Commissioners, thank you for the opportunity to comment further on Santos and Department of Planning, Industry and Environment (DPIE) additional material dated 10 August 2020 and 14 August 2020, respectively. I previously lodged a submission to the IPC Panel on the Narrabri Gas Project (NGP) on 7 August 2020.

SANTOS SUBMISSION – APPENDIX B OPINION OF RICHARD LANCASTER SC

SANTOS SUBMISSION - APPENDIX A ACIL ALLEN

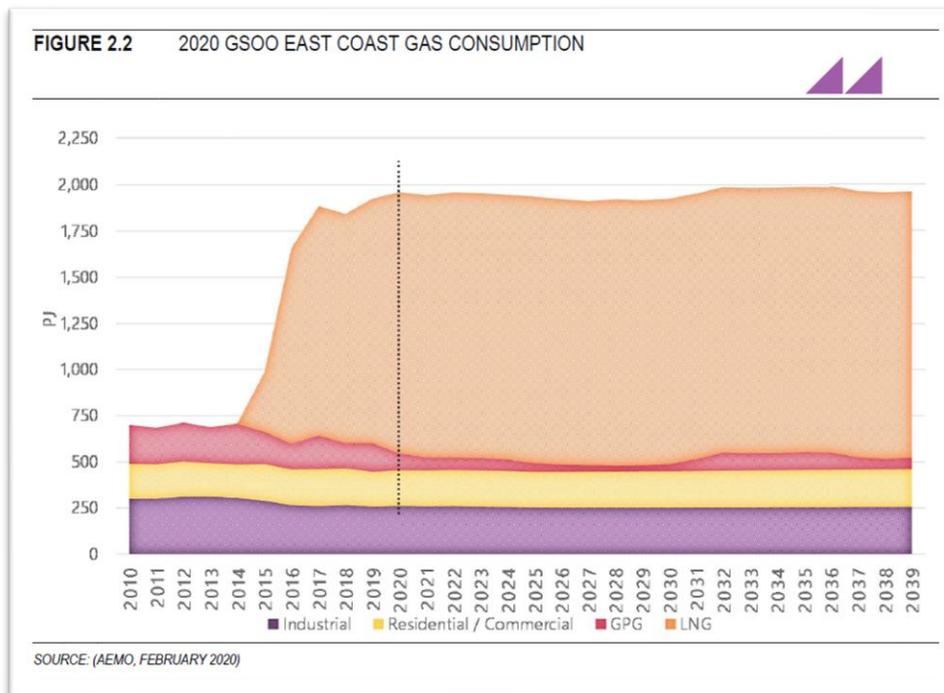
The ACIL Allen report presents that, based on the scenarios modelled, the NGP has a potential 4%-12% benefit to Sydney gas prices not including the fertiliser plant option, or a 3%-9% benefit if the fertiliser plant were to proceed. This is an extremely modest benefit with a high level of uncertainty, based on: the unverified inputs from the proponent, the scenarios modelled, and the timing of the said benefit being “the late 2020s and early 2030s” (Figure ES1).

Note that under this modelling scenario, the dispatch of 20% of gas output from the NGP under a long-term contract has the effect of reducing the potential benefit to gas spot price by 25%.

If this is the case, and long-term contracts are sought, marginal benefit would arise for spot market price.

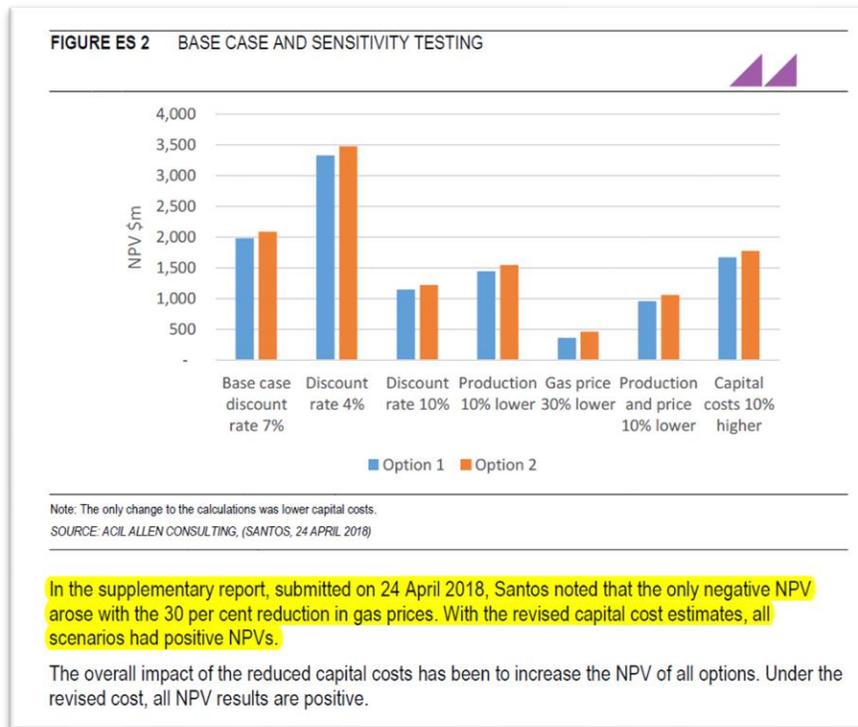
- Figure ES2 in the ACIL Allen report continues to demonstrate how sensitive the NPV of the Project is, including around the capital cost. An increase in capital cost, coupled with a decrease in gas price (a scenario that has not been modelled) would limit and/or potentially erase NPV. This would be further compounded if operating cost is under-estimated (see Figure ES2 over page).
